**Life Changing Chicken**  
**SLIM CHICKENS**  
Chicken Tenders - Buffalo Wings - Sandwiches - Salads - Wraps

**SLIM CHICKEN'S SITE PLAN**  
3860 NORTH TOWER ROAD, AURORA, CO 80011  
**BUILDING ELEVATIONS**

RSN: 1356599  
Permit #: 19-1599017 CM  
RSN: 1418611  
Permit #: 19-1725430 REV

## MYLAR CHANGE APPLICATION FORM

3 NORTH ELEVATION  
SCALE: 1/4" = 1'-0"

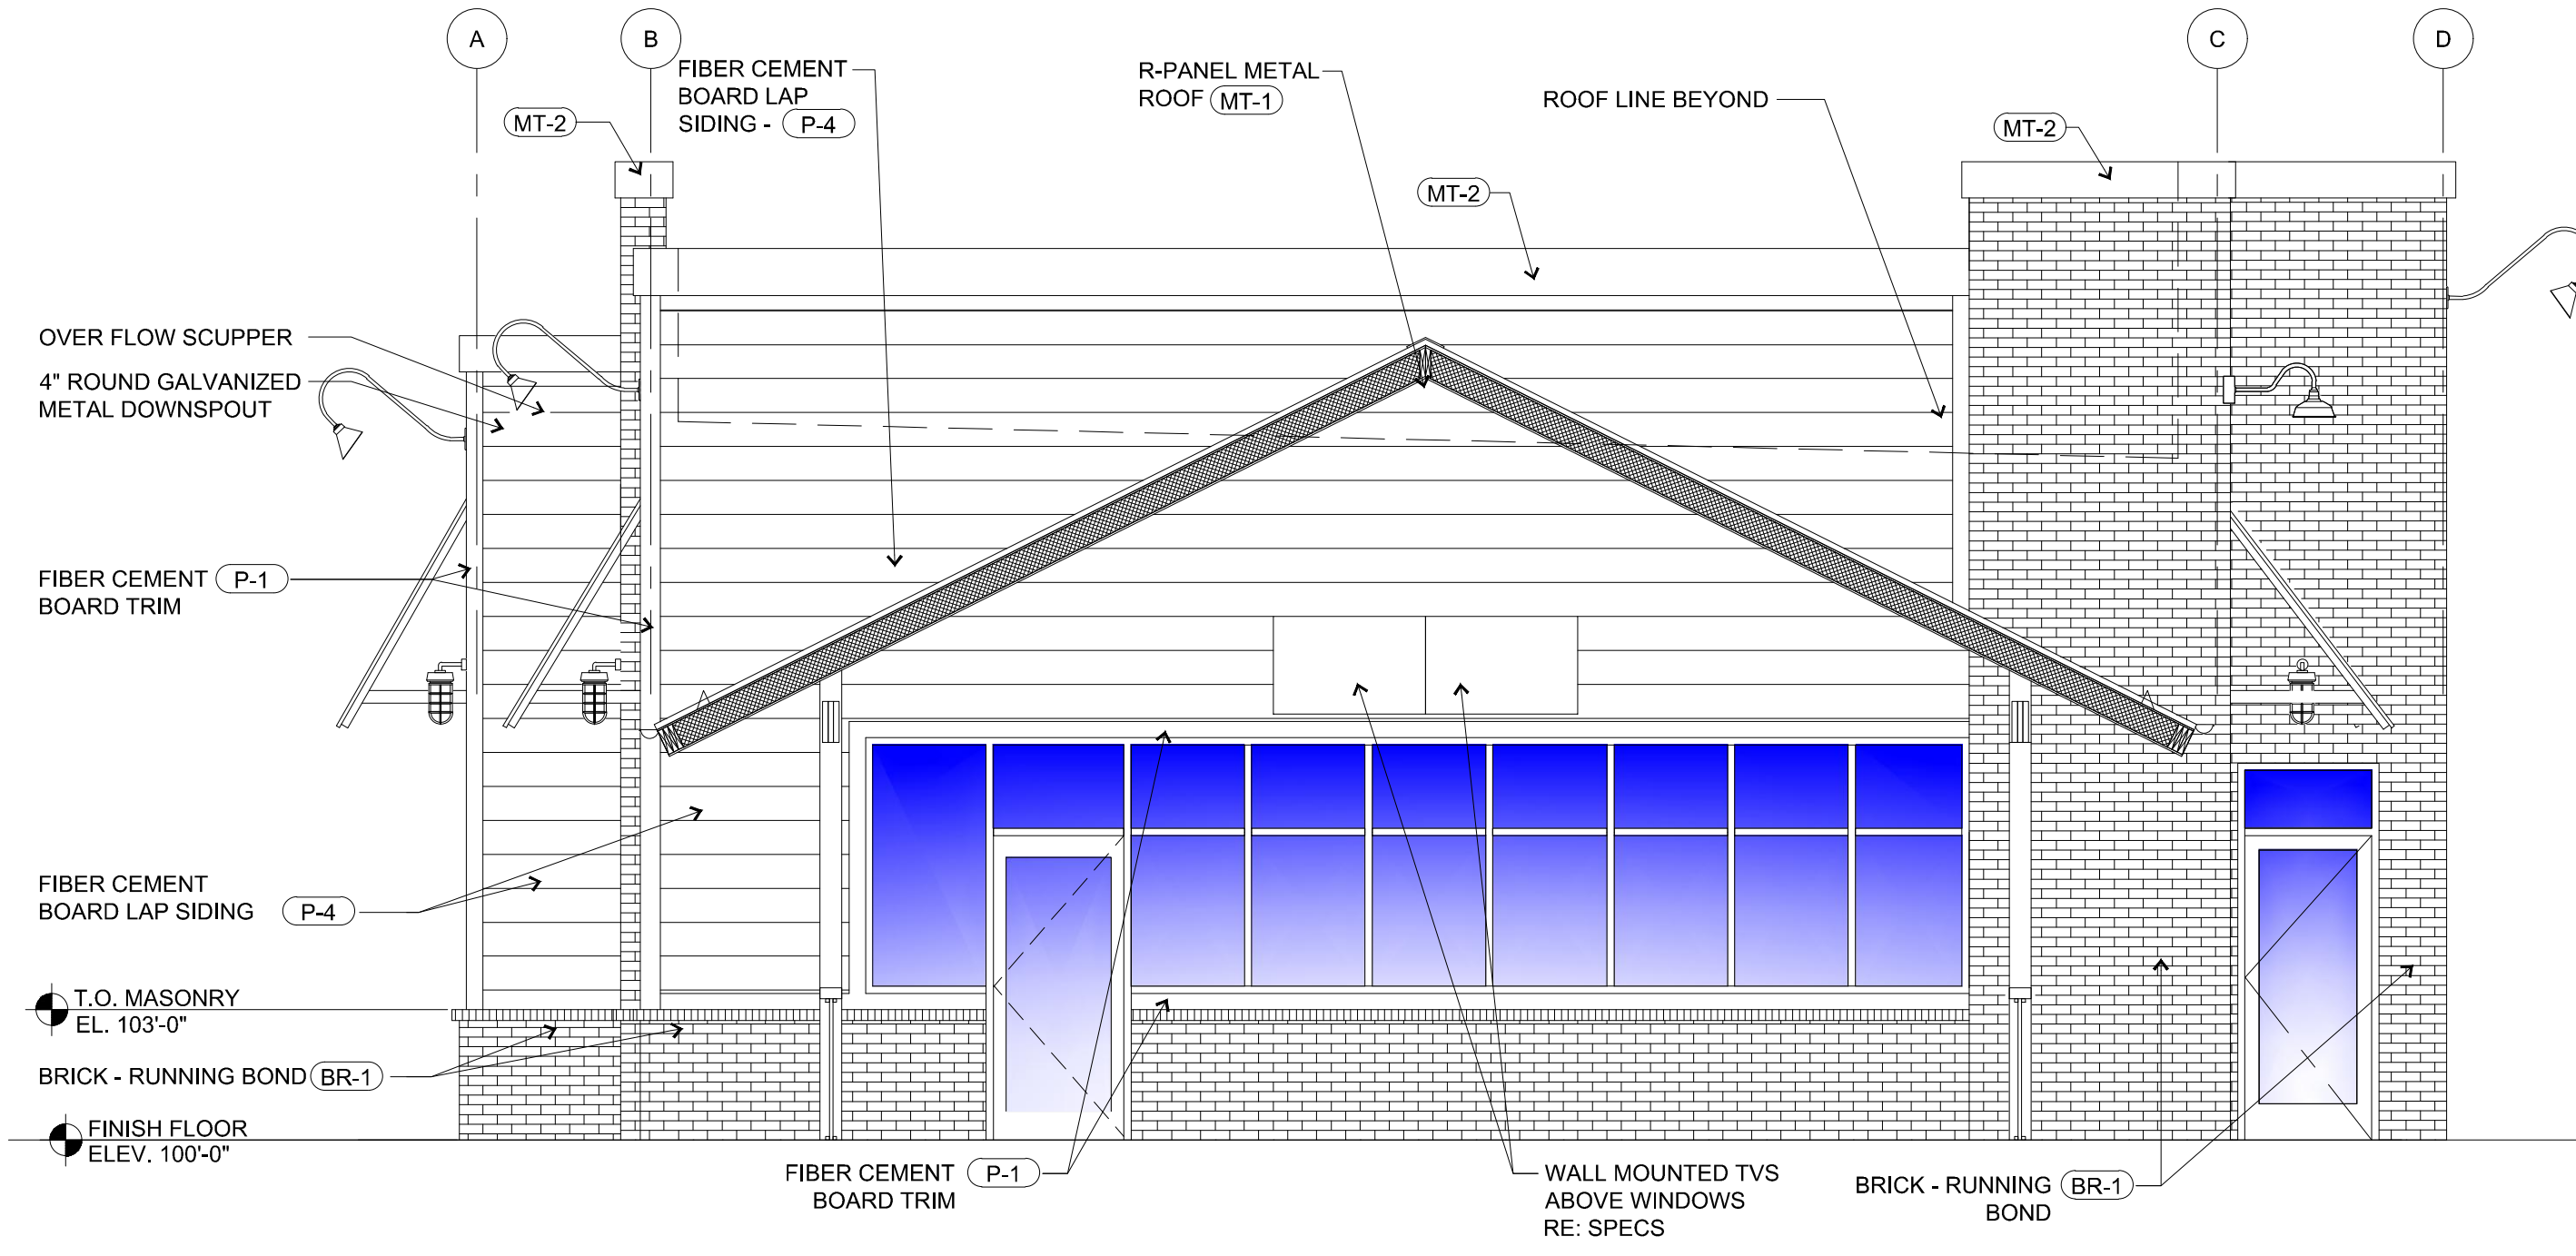
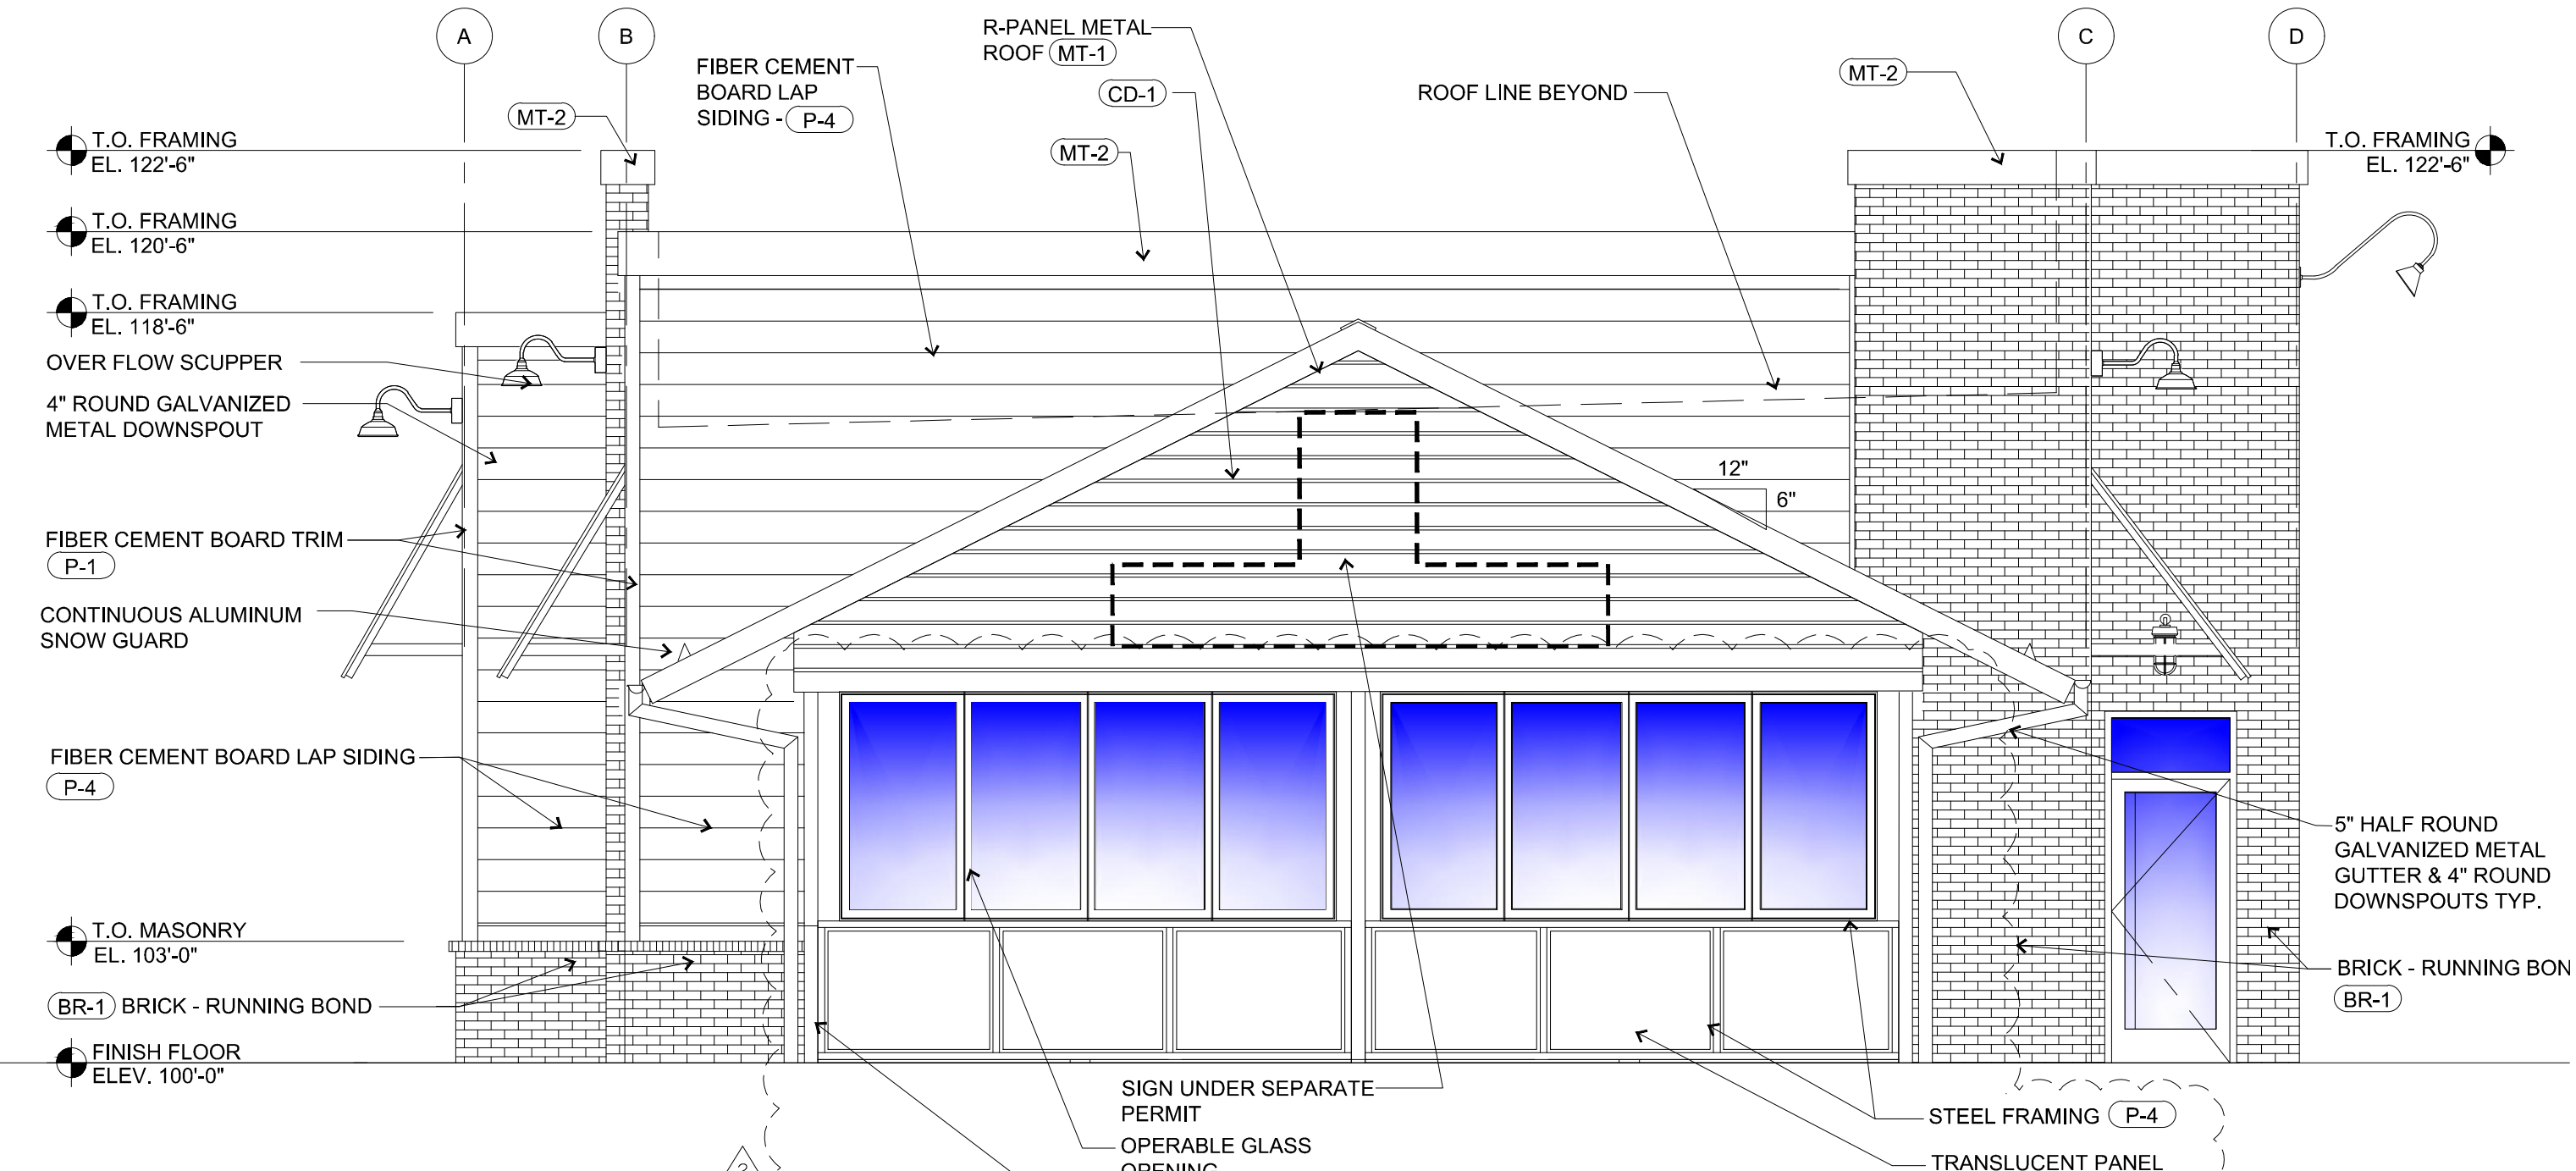
Change north elevation division from 3 panel sections to 2 panel sections. Remove door west elevation of patio.  
 \_\_\_\_\_  
 \_\_\_\_\_  
 \_\_\_\_\_
